# UNITED STATES PATENT AND TRADEMARK OFFICE

| APPLICATION NO.              | FILING DATE | FIRST NAMED INVENTOR | ATTORNEY DOCKET NO. | CONFIRMATION NO. |
|------------------------------|-------------|----------------------|---------------------|------------------|
| 10/802,057                   | 03/17/2004  | Pietro Marcolin      | MARCOLINI           | 1705             |

## DETAILED ACTION

FIG. 1

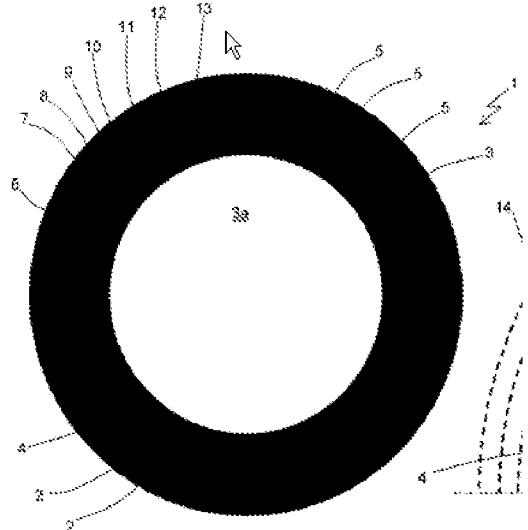
3. In response to the objections of the drawings, Applicant submitted an annotated drawing sheet in which the numerals (6 and 8) and their lead lines have been darkened. This annotated sheet is appreciated, and the drawing objection is withdrawn, as all that was shown in the previous drawing was a completely solid black

ring with lead lines pointing to the black ring. There was no distinction of layers. (see attached).
